The Village at Franklin Park Association, Inc.

Thank you for this opportunity to comment on the proposed Assurance of Discontinuance agreement between the Natural Resources Board and GSD Development, LLC (GSD) and John Philip Gerbode. We are members of the Association Board representing the group of 26 homeowners who have purchased the 26 units that have been constructed on the site of the project referenced on Land Use Permit #6F0569.

**RE: Village at Franklin Park, St. Albans, VT**

**RE: Assurance of Discontinuance Comments  
GSD Enterprises, Inc. – GSD Development, LLC  
Village at Franklin Park, St. Albans, Vermont**

**Statement of Fact #9 – Recharge Swale**

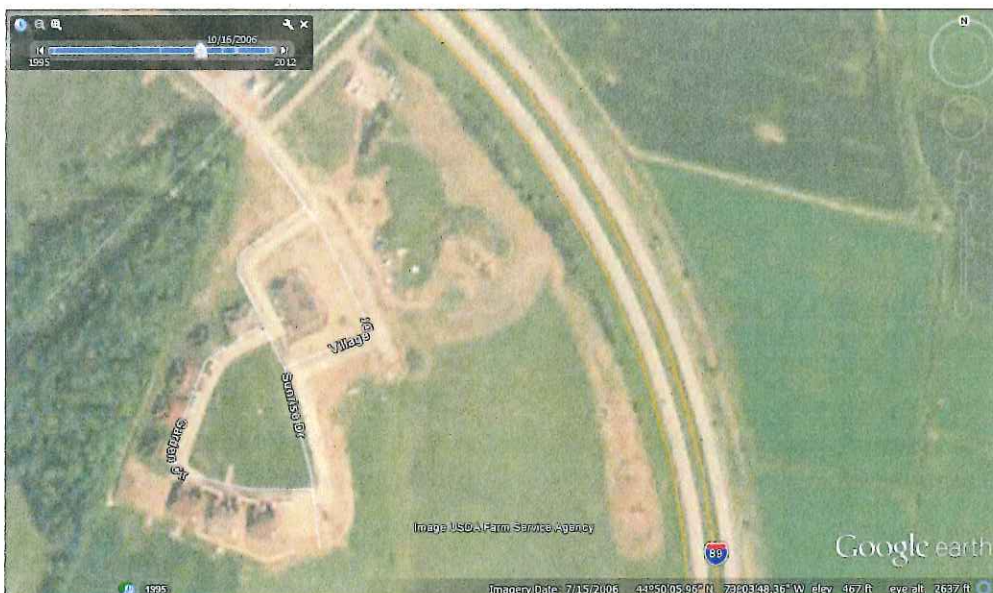
With regard to the stormwater swale located along the western property line, the respondent's claim that "Permit 3604-9015 requires approximately 16 linear feet of properly constructed grass channels to meet

the recharge requirement” is not correct. The applicant took advantage of the Grass Channel Credit to meet the recharge requirement in accordance with Section 3.5 of the *Vermont Stormwater Treatment Standards* in effect at the time. A condition of taking this credit is that the length of the channels must be equal to the length of the roadways. That is why 4,000 linear feet of swales were originally designed and permitted.

As we reviewed in the previous report there are additional concerns with the western swale. It is likely the 6” drainage pipe and crushed stone decreases the amount of standing water thus reducing the threat of mosquitos around the residences, but it certainly is not beneficial hydraulically in larger storms. Although the rules allow for swales to be designed to accommodate the 10-year storm event, a swale at the rear of residences should be designed for the 100-year storm event plus sufficient freeboard to account for accumulation of sediment and potential buildup of snow and ice (i.e. cold considerations). I’m sure you and your neighbors would not find it acceptable to have your houses flooded every 10 years. Residents already experience threatening water during heavy rainfall events, and upon construction of Phase IV additional runoff will be directed toward this swale according to the design.

Please note that the design drawings include a Typical Swale Section (Sheet S-19) with a minimum bottom width of 2’ and side slopes of 4’ horizontal to 1’ vertical. The grading design shows side slopes of 3’ horizontal to 1’ vertical (Sheets S-2 and S-3) though there appear to be problems with the contouring at the rear of units 412 and 414. Based on my field measurements the swale at the rear of Garden Circle was constructed with a 1’ bottom width and much steeper side slopes (2’ horizontal to 1’ vertical). This certainly reduces the hydraulic capacity of the swale and contributes to the high water problems the homeowners have experienced.

This swale should be redesigned and reconstructed to protect the residents from future flooding and meet permit requirements.

**Statement of Fact #23 – Forebay Inlet**

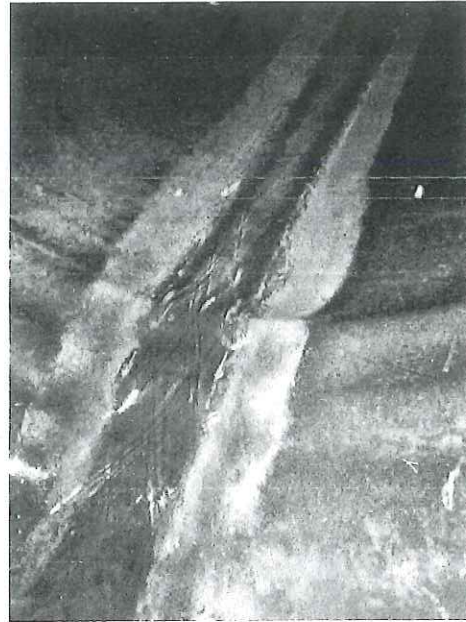
As of my most recent site visit, 9/12/13, the new end section had not been installed. (See photo below)

**Statement of Fact #25 – Stormwater Construction Issues**

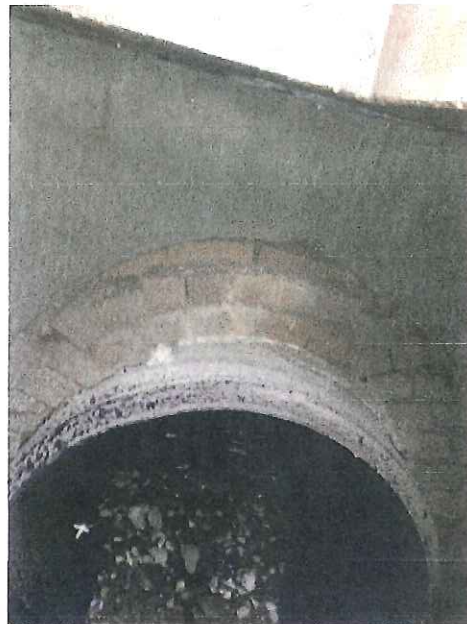
One of the major construction issues within this development is the problem of settlement of the areas adjacent to catch basins. The main reason for this is a lack of adequate compaction of material around catch basins and under drainage pipes. This has resulted in the creation of depressions and sinkholes at numerous catch basins. The developer has attempted to patch the asphalt in these areas, but this is a temporary fix that only masks the underlying problem. Beneath the surface several pipes are beginning to fail just outside the catch basins (CB 37 and CB 41 are particularly bad and worse than I observed just two years ago). There are several others that I was not able to inspect due to their depth below grade.

On inspection it is obvious at these locations that the material beneath the pipes immediately outside the catch basin was not properly compacted. The design drawings refer to specifications for requirements regarding compaction of backfill. Cross Consulting Engineers, P.C. supplied us with specifications for Trenching (Section 02225), Site Water Lines (Section 02667) and Site Sanitary Sewerage Systems (Section 02732), but according to Mr. Garceau they were unable to locate the specification for the Site Storm Sewerage and Underdrain Systems (Section 02722). The specification for Trenching calls for "compaction to 95% Modified Proctor density" "under structural areas and within 36" of structural areas." I've included a copy of these specifications. I've also included Advanced Drainage Systems (ADS) Technical Note 5.04 regarding *HDPE Connections to Manholes and Structures*. ADS is believed to be the manufacturer of the HDPE piping utilized on this project. Their details also specifically state "Performance highly dependent on installation. Contractor must insure manhole gasket is uniformly seated around structure adapter. Extra precautions must be taken to prevent differential settlement between pipe and manhole." If the piping and catch basins had been installed with proper compaction in accordance with the design drawings, specifications and manufacturer specifications the HDPE pipes would not be failing.

Additionally settlement was observed along the pipes to and from CB 55.

Many of the existing on-site connections are not properly constructed. The cracks discussed above allow sediment to wash from around the sides of the pipes and catch basins resulting in void spaces and further sinkholes. Booted connections are far superior to grouted connections due to their flexibility, resiliency and minimal maintenance requirements. I assume this is why Cross Consulting included them in the approved design. I recommend that all deformed pipes be replaced and all catch basins with

inadequate connections be properly reconstructed or replaced with catch basins that contain the specified neoprene boot connections.
